9 August 2013 (updated 1 August 2014)

SUBJECT: Product Support Plan for 2300D and 2301D Controls

Attachment A – Wiring Terminal Changes

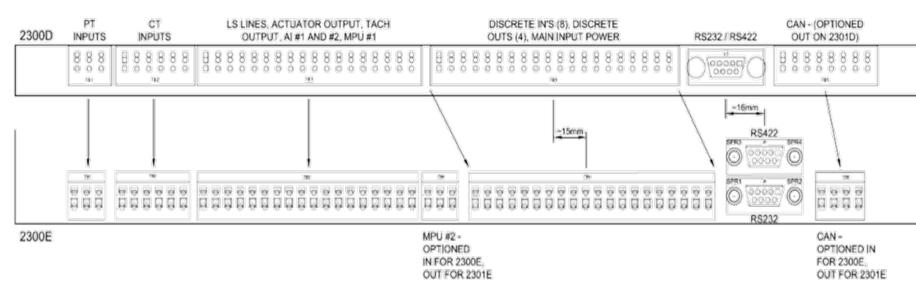
The terminals are changing from the current lever type spring cage connector to another spring cage connector that does not have a lever.

Due to the addition of new I/O in the 2300E model, the terminal spacing on both the 2300E and 2301E will change slightly from the 'D' versions:

- The PT, CT, Actuator Out, Analog In, and 1st MPU input connections are not moved.
- The Discrete In, Discrete Out, and main power input connections are moved to the right approximately 15 mm.
- The RS-232/RS-422 port moves to the right approximately 13 mm.
